Subject: Improvements in Trunk Lid Closing Bulletin Type: Field Fix Conditional

Bulletin No: TS35-FC-2602

Vehicle Model and Number of Vehicle:
TS35 - 83

Explain technical summary of the modification implemented:	The ventilation vents inside the vehicle have been removed. New ventilation vents have been added to the floorboard assembly.
Under what conditions is this service bulletin applicable?:	This procedure will be implemented if complaints are received regarding trunk lids not closing.

View from the vehicle for ventilation

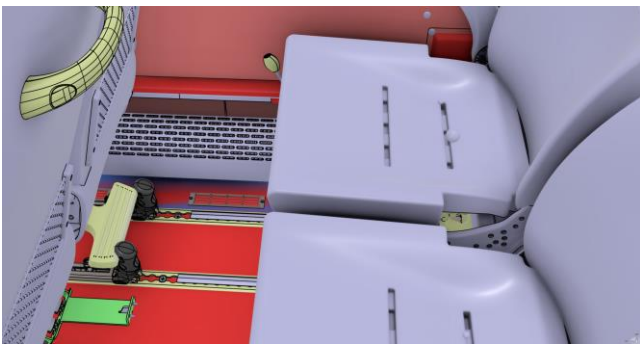
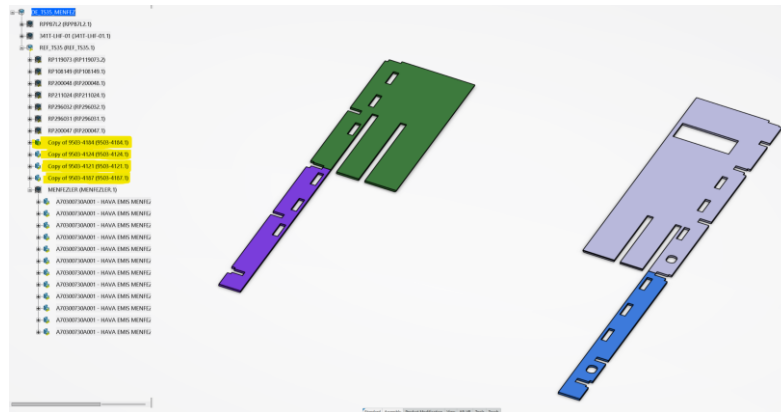
1. The two air vents on the vehicle will be removed. The gap will be sealed by applying sealant to the area marked in yellow in the image below. The vents will then be reinstalled.

View from inside the vehicle

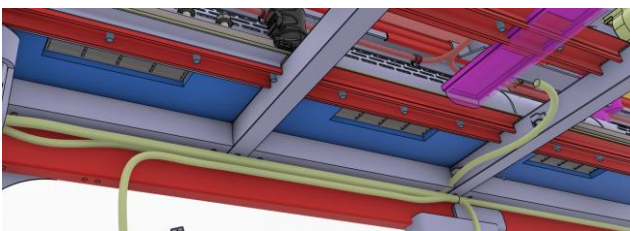
- New vents are required to be added, positioned on the inner side of the luggage compartment covers, mounted on the floor panels. Inside the vehicle, they will be located at floor level beneath the convector. Three vents will be added to each cover, resulting in a total of 12 new vents across the vehicle. The locations of these ventilation openings can be observed in both the technical drawings and the corresponding vehicle views provided in the following figures.

Assemblies to be modified:

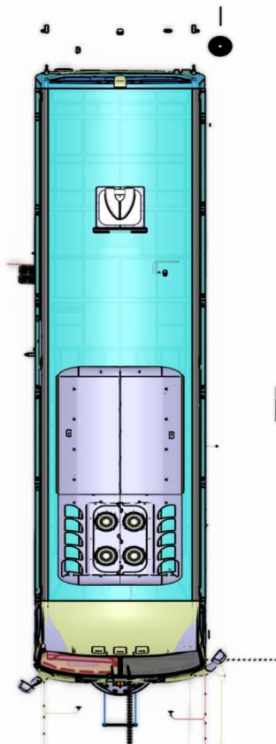
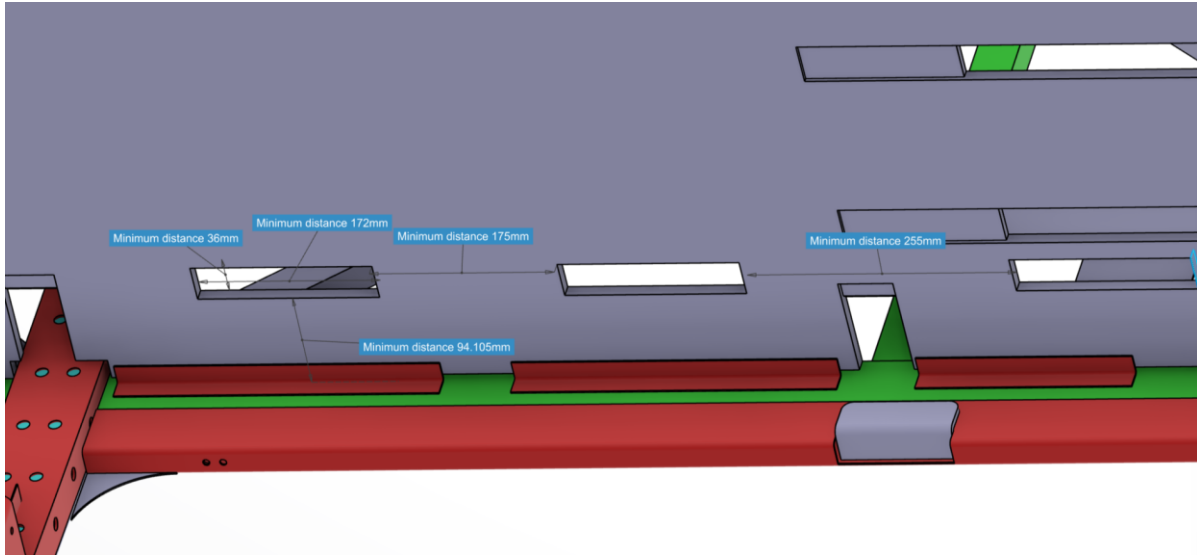
- RP200048Y – Floor Board and Trim Assembly (Without Lift)
- RP200047Y – Floor Board and Trim Assembly (With Lift)
- RP167014Y – Battery and Tank Compartment Panel Assembly (TS35)
- RP200031Y – Luggage Compartment Trim and Floor Board Assembly

Top View of the Vehicle

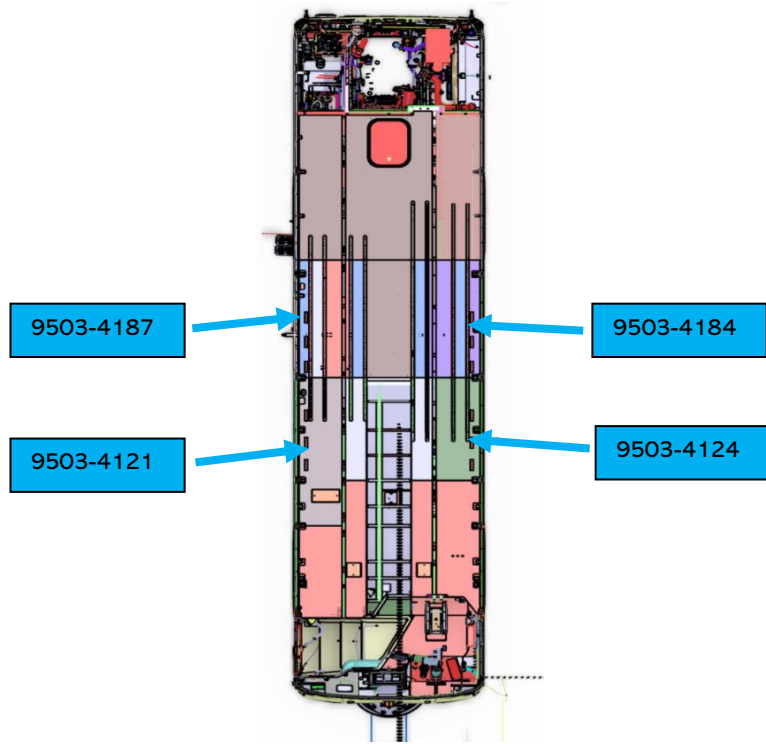
3. The dimensional specifications for creating the vent openings on the floor board assembly, corresponding to parts (9503-4121, 9503-4124, 9503-4184 and 9503-4187) are indicated in the provided visual reference.
